**Proposed Temporary Animal Boarding Establishment (Dog Kennel)  
for a Period of 3 Years and Filling of Land at Lots 1347 S.W & 1347  
S.AD in D.D.107, Fung Kat Heung, Kam Tin, Yuen Long, N.T.**

This letter intends to supersede our letter dated 9.9.2024. Our response to the comments of the CE/MN, DSD is as follows:

**Annex 1 Drainage Proposal**

Figure 4. Intensity – Duration – Frequency Curves  
(for durations not exceeding 4 hours)

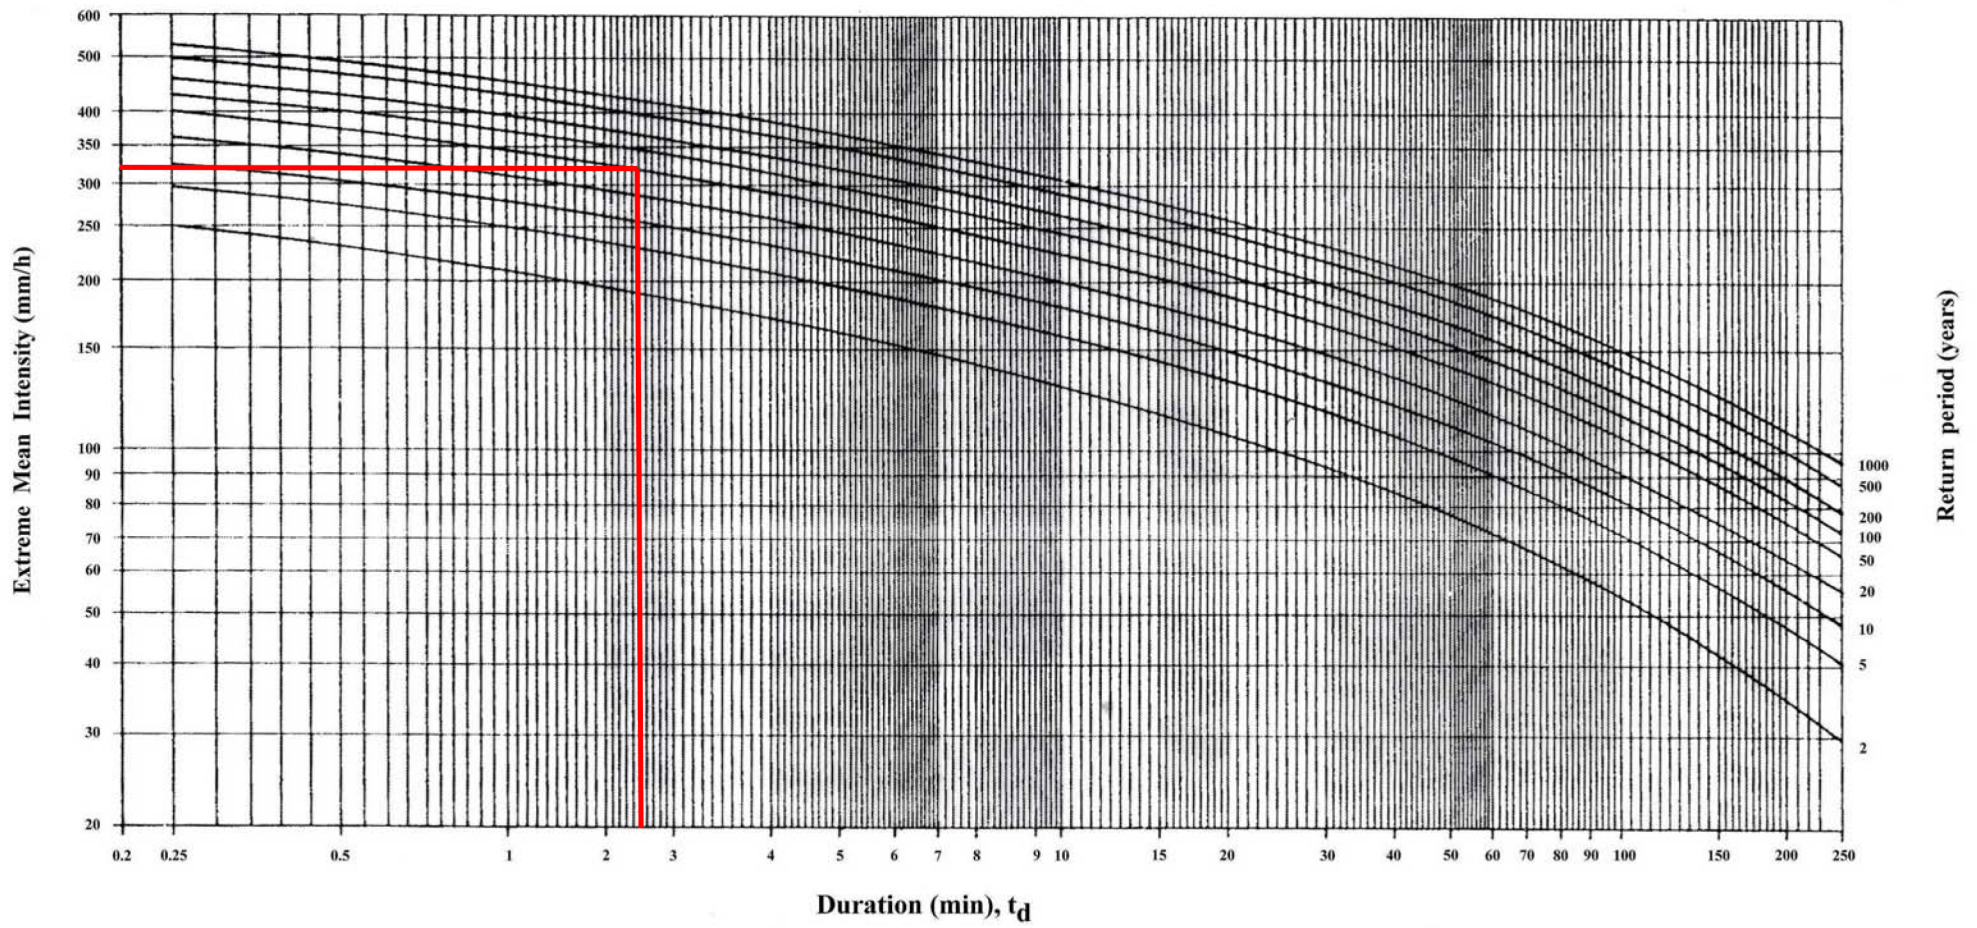
CE/MN, DSD's comments	Applicant's response
<p>(a) Section 1.2: Please provide relevant IDF curves and chart of the rapid design of channels with your designed values indicated on curves/ chart for reference.</p> <p>(b) For Section B-B shown in the drainage plan, please provide a cross section showing the existing watercourse as well as the boundary of the proposed development.</p> <p>(c) Please provide a cross-section demonstrating how the proposed development would not affect the existing watercourse/natural stream.</p> <p>(d) All proposed drainage facilities and walls/ hoarding should be shown in cross sections.</p> <p>(e) The existing drainage facilities, to which the stormwater of the development from the subject site would discharge, are not maintained by this office. The applicant should identify the owner of the existing drainage facilities to which the proposed connection will be made. The applicant shall demonstrate that the proposed drainage construction / improvement / modification works and the operation of the drainage can be practicably implemented.</p>	<p>Noted. Please see attached.</p> <p>Noted. Please see updated drainage plan.</p> <p>Noted. Please see updated drainage plan. Site hoarding will be provided to separate the site from the watercourse.</p> <p>Noted. Please see updated drainage plan.</p> <p>Noted. The existing drainage facilities, to which the stormwater of the development from the subject site would discharge, are not maintained by CE/MN, DSD. The applicant would identify the owner of the existing drainage facilities to which the proposed connection will be made. The applicant shall demonstrate that the proposed drainage construction / improvement / modification works and the operation of the drainage can be practicably implemented.</p>

With reference to the Intensity-Duration-Frequency Curves provided in the abovementioned manual, the mean rainfall intensity (i) for 1 in 50 recurrent flooding period is found to be 325 mm/hr

Drawing No. 圖號:  
**Figure 5**

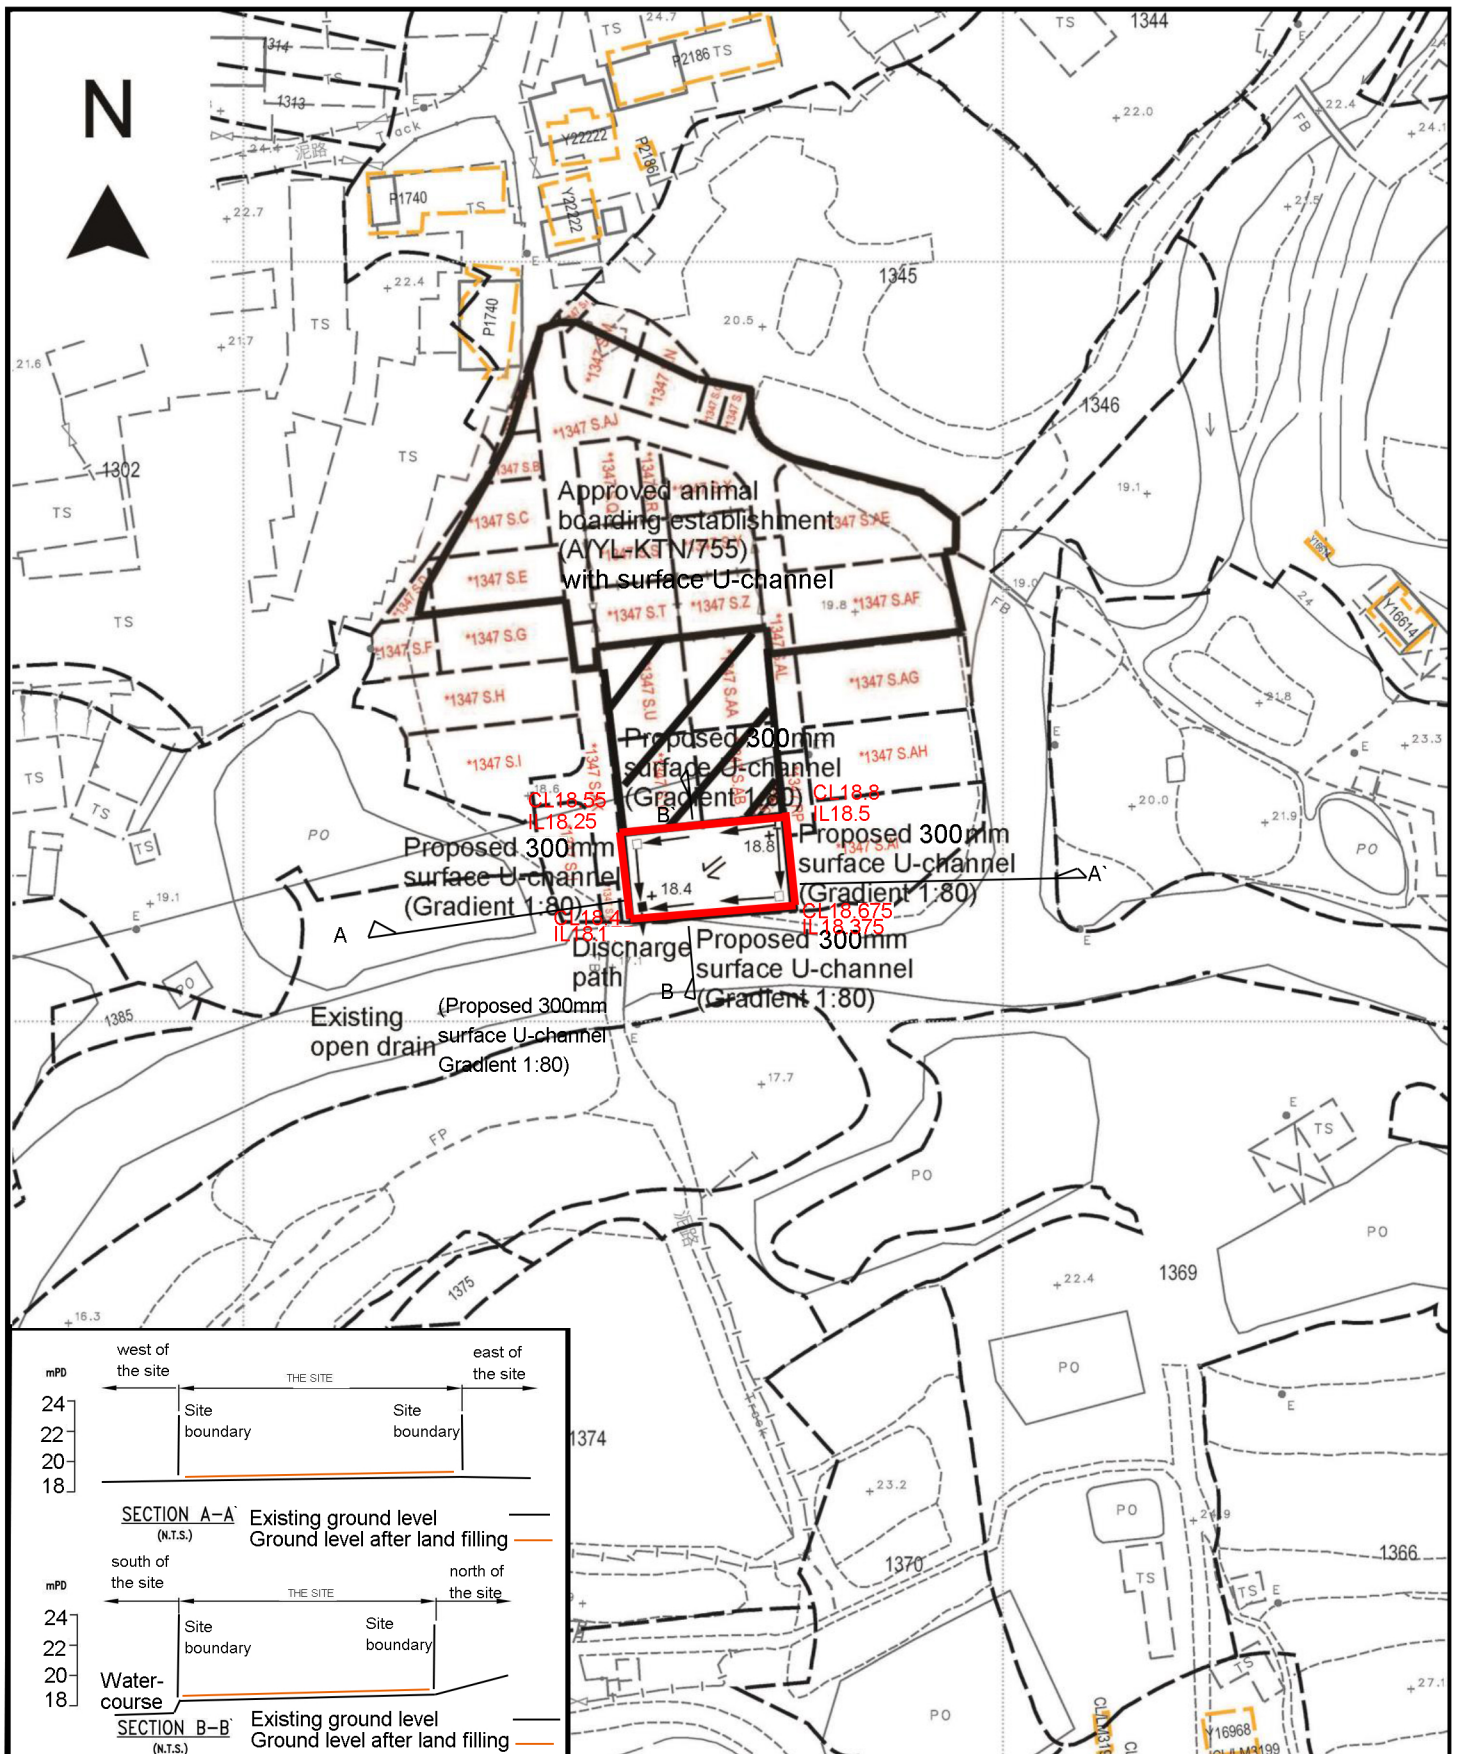
<p>(f) The applicant should check and ensure the hydraulic capacity of the existing drainage facilities would not be adversely affected by the captioned development. Please provide site photos to show existing condition of the existing drainage facilities which receives the discharge from the application site.</p> <p>(g) Please clarify whether any walls or hoarding would be erected along the site boundary. Where walls or hoarding are erected/ laid along the site boundary, adequate opening should be provided to intercept the existing overland flow passing through the site.</p> <p>(h) Standard details should be provided to indicate the sectional details of the proposed u-channel and the catchpit.</p> <p>(i) Sand trap or provision alike should be provided before the collected runoff is discharged to the public drainage facilities.</p> <p>(j) The development should neither obstruct overland flow nor adversely affect existing natural streams, village drains, ditches and the adjacent areas, etc.</p> <p>(k) The applicant(s) shall resolve any conflict/disagreement with relevant lot owner(s) and seek LandsD's permission for laying new drains/channels and/or modifying/upgrading existing ones in other private lots or on Government land (where required) outside the application site(s).</p>	<p>Noted. The existing drainage facilities is the only drainage facilities adjacent to the application site for dissipation. The discharge from the application site is minimal because the land filling at the application site is minimal. The additional discharge would not affect the existing drainage facilities.</p> <p>Site hoarding would be provided along the site periphery as shown on the updated drainage plan. 100mm opening would be provided at the toe of the site hoarding to allow uninterrupted flow of stormwater.</p> <p>Noted. Please see attached drawings.</p> <p>Sand trap is proposed at the terminal catchpit as shown in the updated drainage plan.</p> <p>The development would neither obstruct overland flow nor adversely affect existing natural streams, village drains, ditches and the adjacent areas, etc.</p> <p>The applicant(s) shall resolve any conflict/disagreement with relevant lot owner(s) and seek LandsD's permission for laying new drains/channels and/or modifying/upgrading existing ones in other private lots or on Government land (where required) outside the application site(s).</p>

1.3.1 Subject to the calculations in 1.2 above, it is determined that proposed 300mm surface U-channel along the site periphery is adequate to intercept storm water passing through and generated at the application site (**Figure 5**).

1.3.2 Catchpit will be provided at the turning point of the surface U-channel. Sand trap or alike will be provided at the terminal catchpit.

1.3.3 The collected stormwater will then be dissipate to the open drain to the immediate south of the application site.
